Applicable Urban Design Priorities that Project Should Achieve

Alamo Manhattan_Bishop Arts
Streetcar Plaza

SITE PLAN

Bishop Arts Station
Dallas, Texas

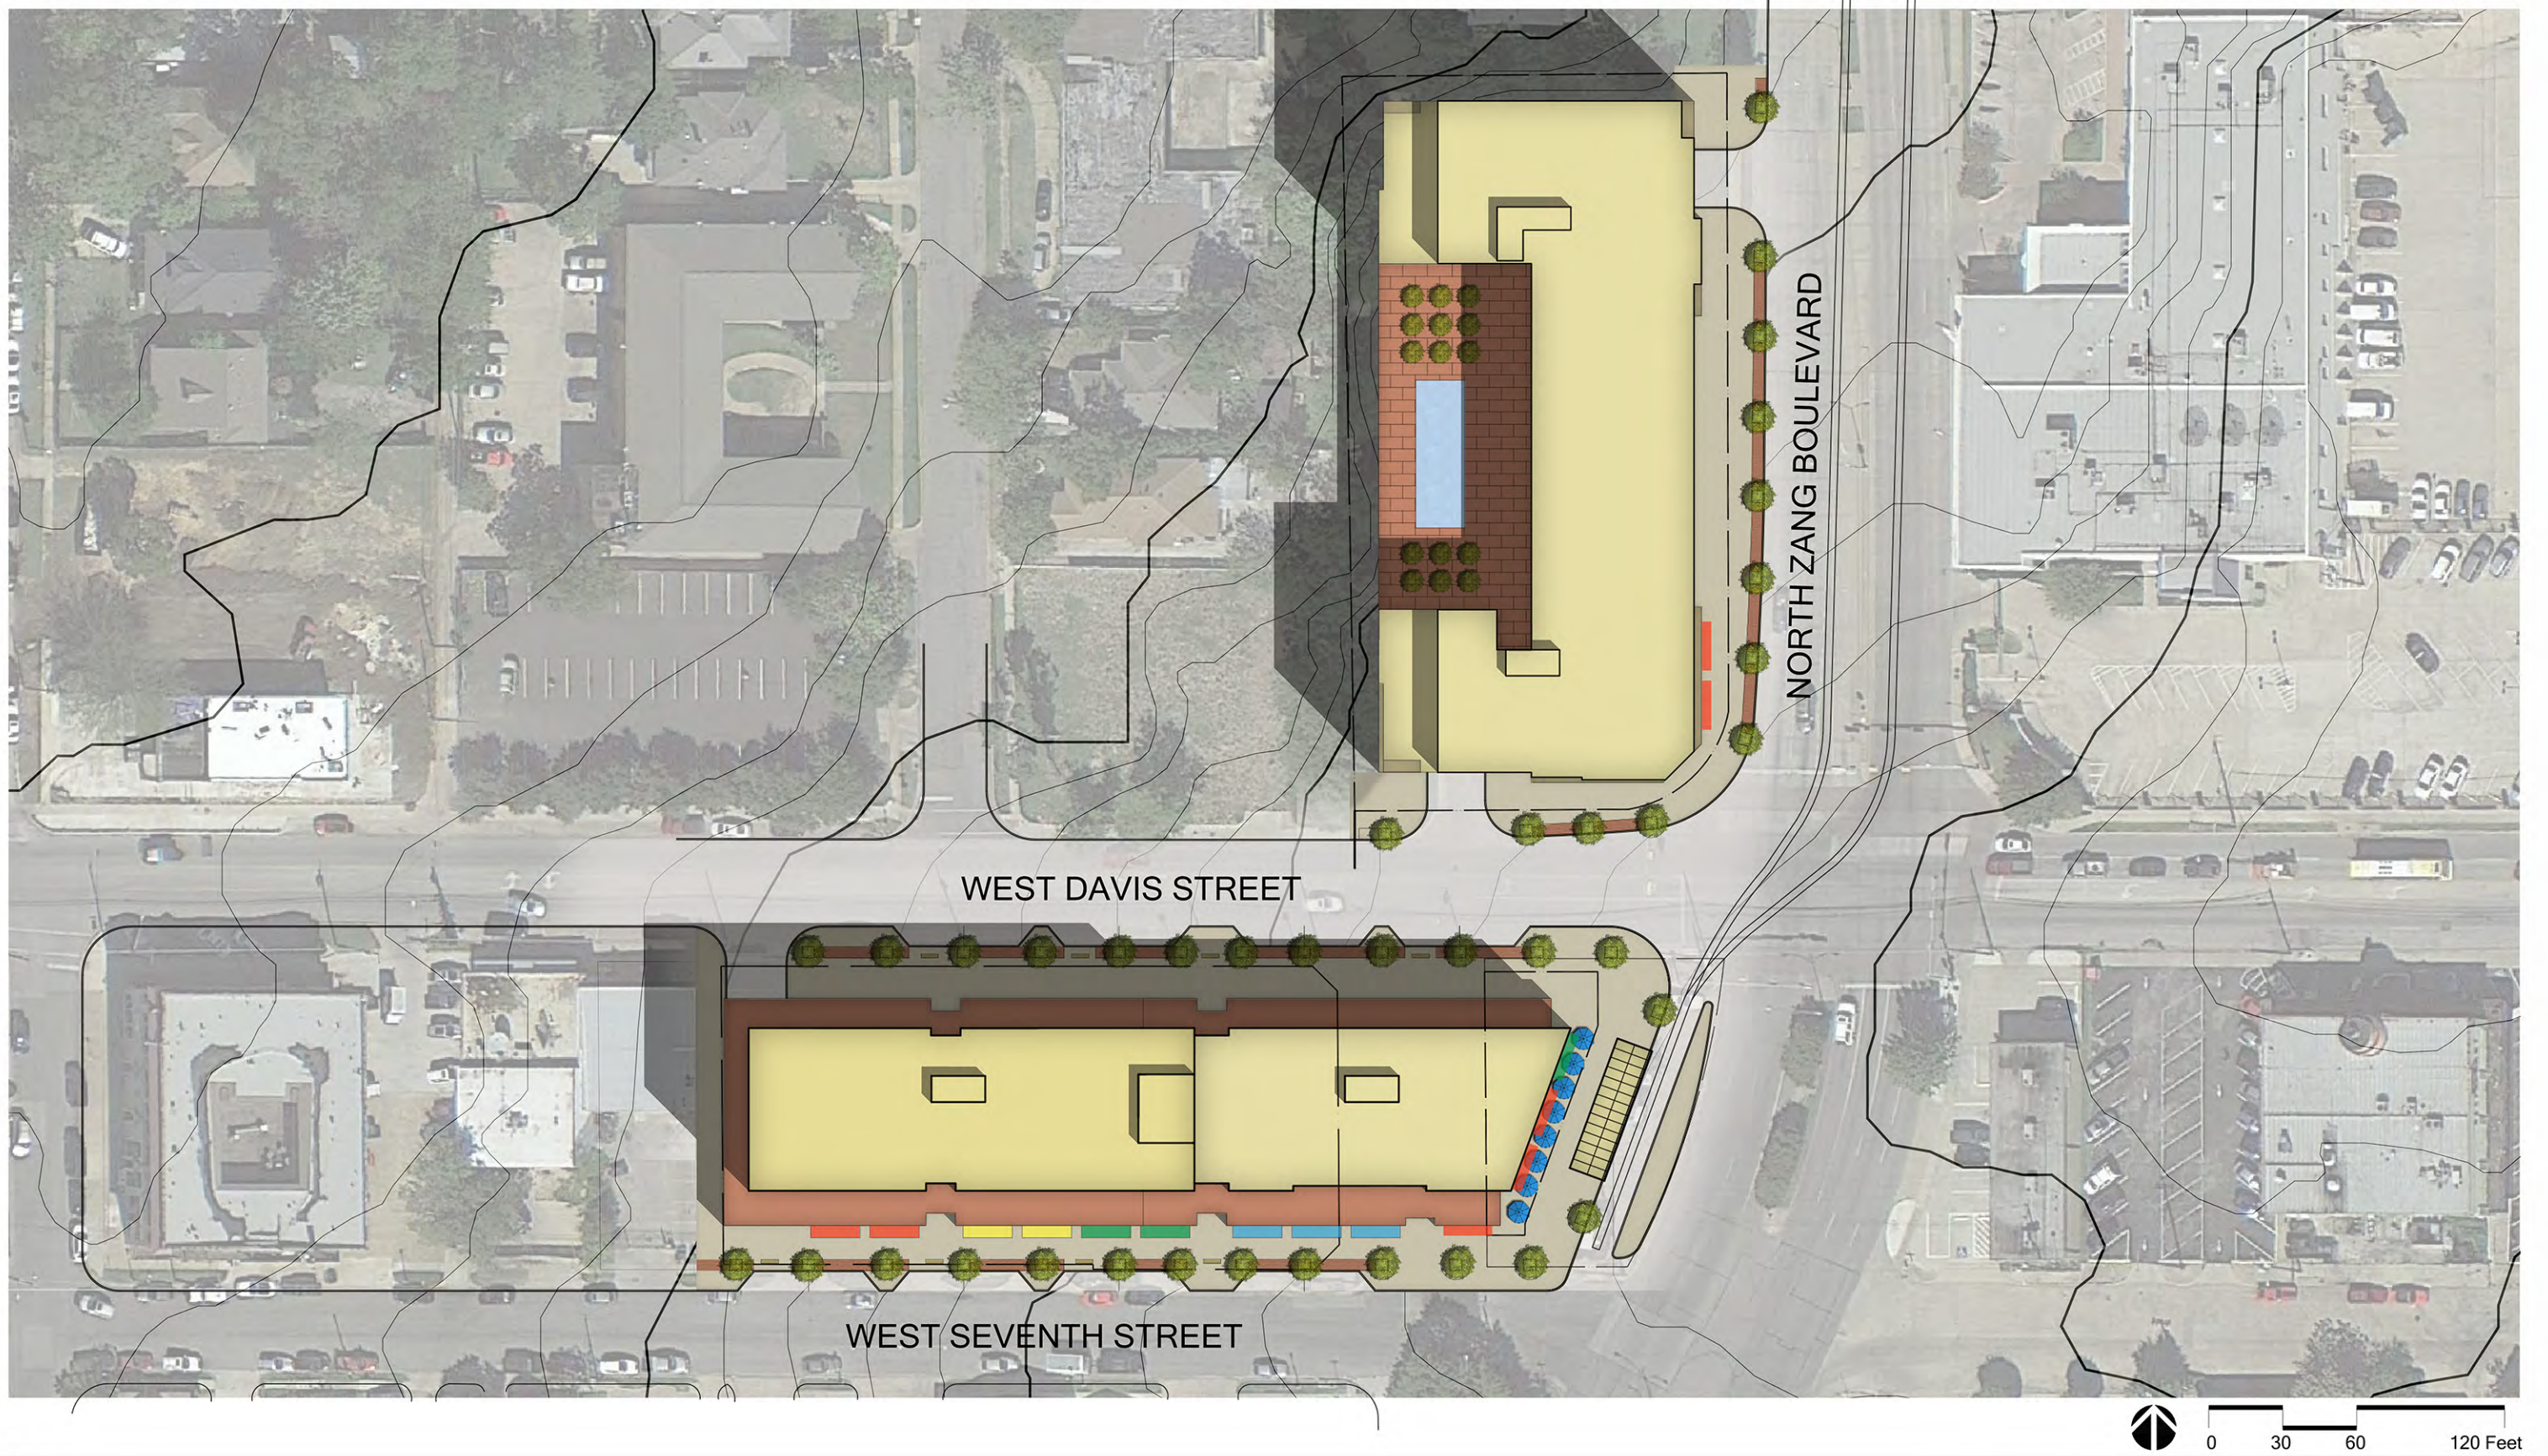
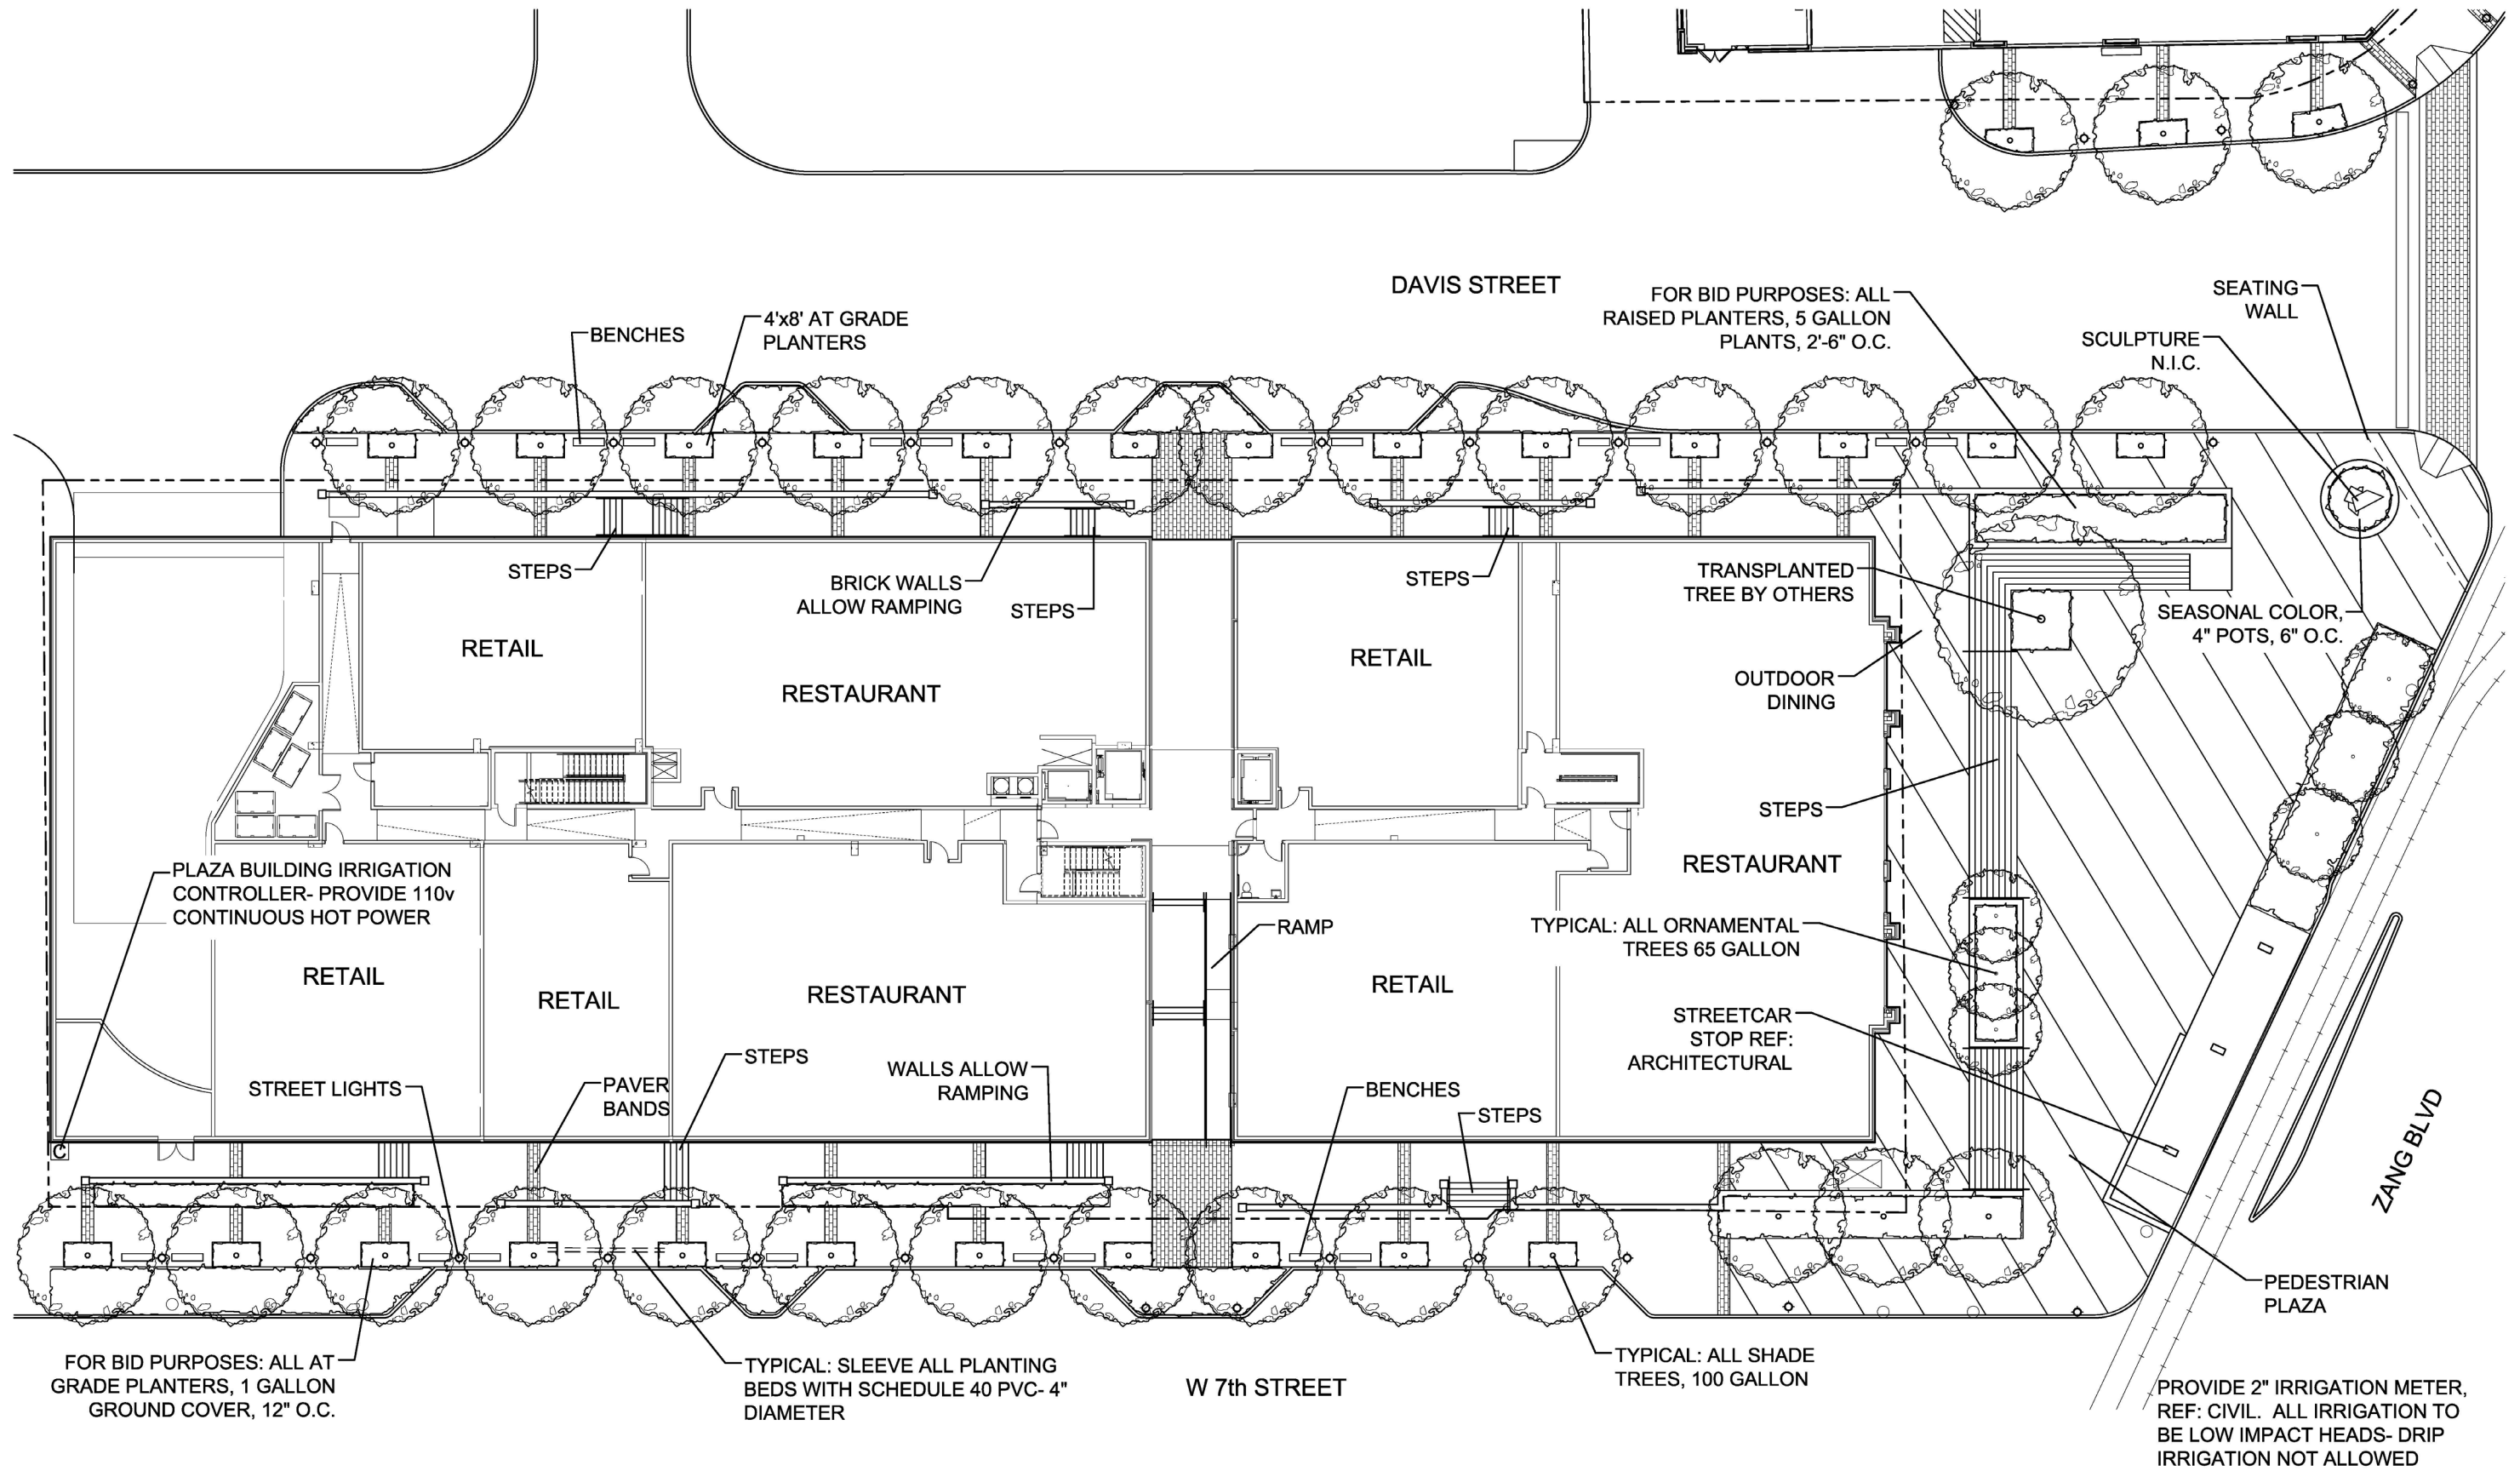
- [1] Regularize locations and repetition of fixed elements within the public realm (seating, low walls, planters etc.) that restrict the pedestrian throughway -
Sidewalks should provide a clear 7' throughway zone that is unobstructed by hardscape elements or streetscape amenities.

- [2] Provide increased shade with additional trees wherever possible in large hardscape areas to create shaded areas people can comfortably linger in -
Consider the use of trees to promote shaded areas within the plaza wherever possible.

- [3] Explore opportunities to relocate existing large site trees to the plaza area as organizing features of the overall design scheme -
Consider relocating the large existing live oak trees located on the future building site to the plaza to serve as organizing features of the plaza elements that would provide large shaded areas for both the dining areas and the public space.

- [3] Utilize a combination of seat walls and non-barrier forming elements such as stairs or ramps to negotiate grade while comfortably accommodating pedestrian movement into the neighborhood -
Grade changes throughout the plaza and connecting sidewalks should be handled in a manner that creates usable amenities while efficiently and safely conveying pedestrians into the neighborhood.
